F4683

RE: ***Comments from Beta Group 151 Grove Street, Self Storage Facility Site Plan***

On behalf of our client, Mark Yadisernia, Guerriere & Halnon, Inc. has prepared the following information to address comments contained in the letter to the Planning Board from BETA Group.

Subcatchment 1S: Driveway Apron

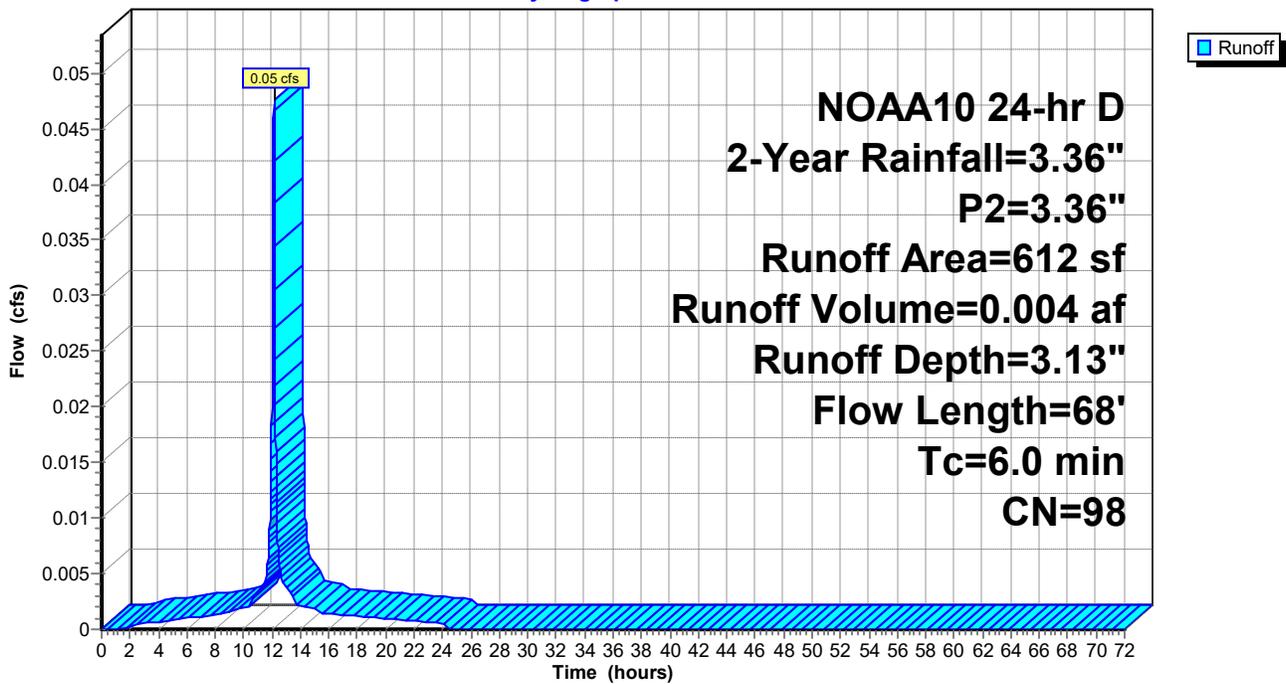
SW10A. A small portion of the driveway flows untreated towards Grove Street. Either provide treatment for this runoff or a "de minimus" calculation to demonstrate compliance with the standards.

G.H. Response: De Minimis calculations have been performed and have now been included in the submittal.

Summary for Subcatchment 1S: Driveway Apron

Runoff = 0.05 cfs @ 12.13 hrs, Volume= 0.004 af, Depth= 3.13"
Routed to Pond AP-2 : GROVE ST
